Annual Review

Energy Management System (EMS) Model Updates and Quality Assurance (QA)

Manual 03A

November 16, 2022

Manual Revision:
(Appendix C Exhibit 14)

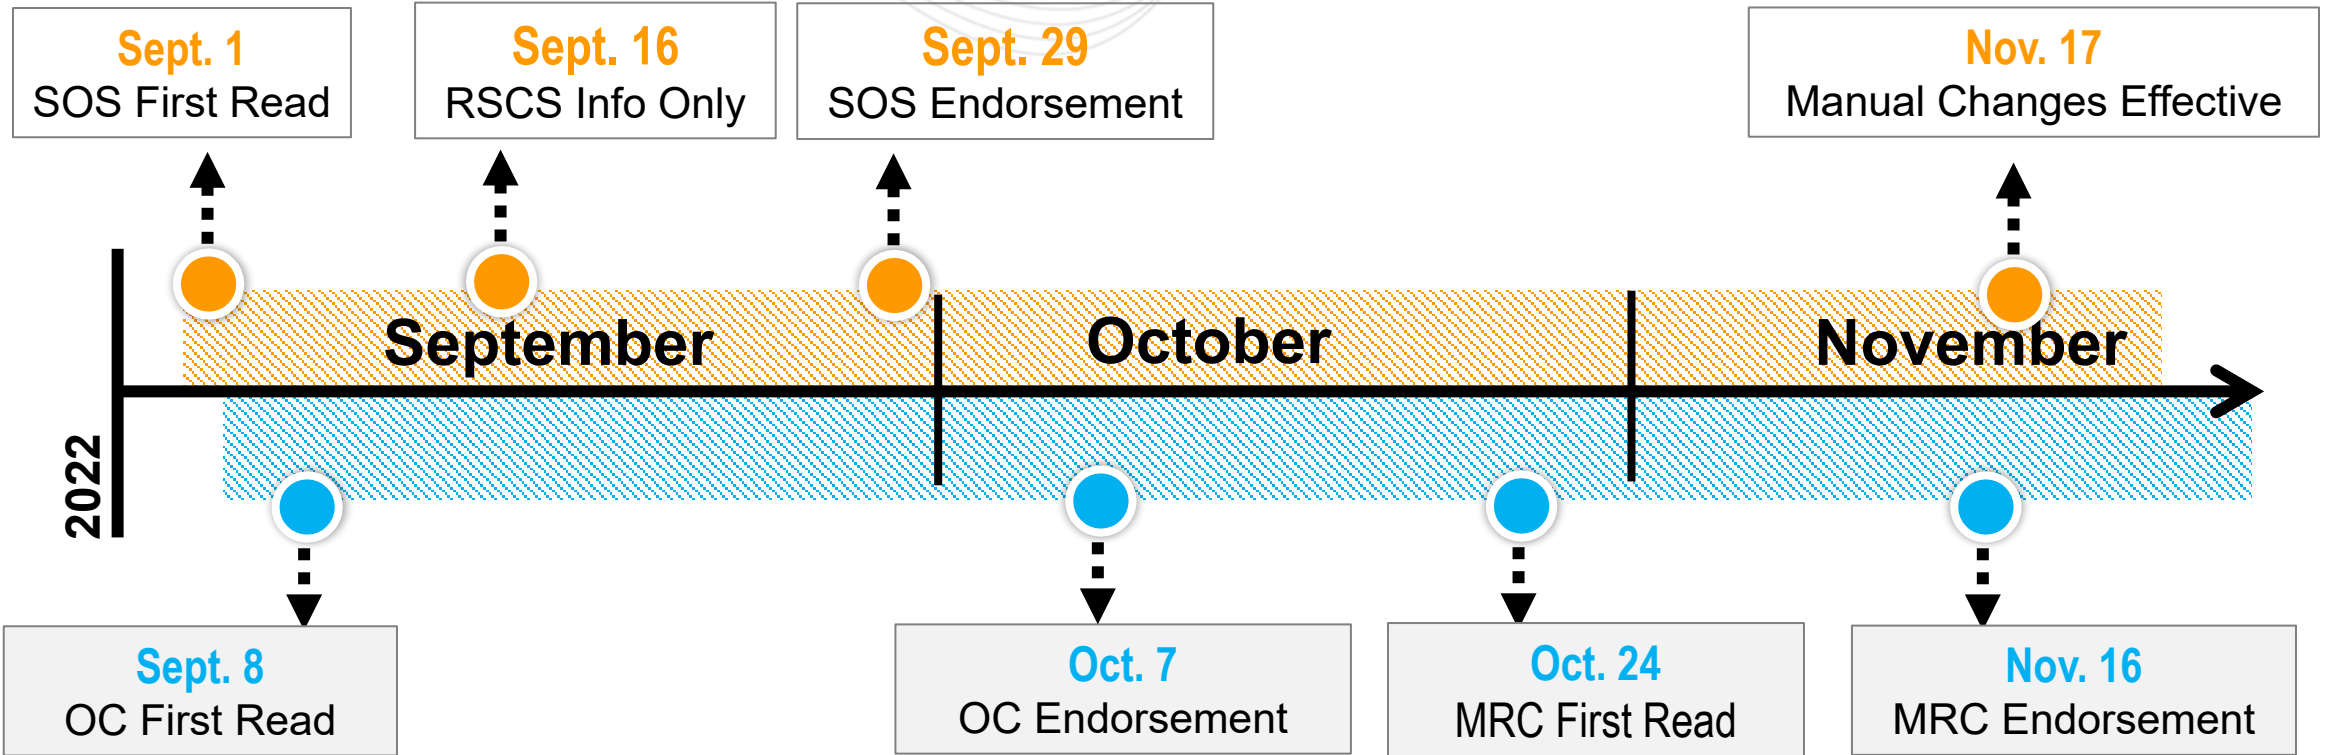
During our annual review we saw an opportunity for clarification (names)

- Definitions don't change
- Name changes for clarification
 - Not Monitored, No Status → Not Monitored-No Status
 - Reliability & Markets → Reliability and Markets
 - External → External Reliability
 - GSU → Generation Equipment
 - Future → Pending
- Annual MP Process does not change

- Not Monitored, No Status to Not Monitored-No Status
- Reliability & Markets to Reliability and Markets
- External to External Reliability
- GSU to Generation Equipment
- Future to Pending
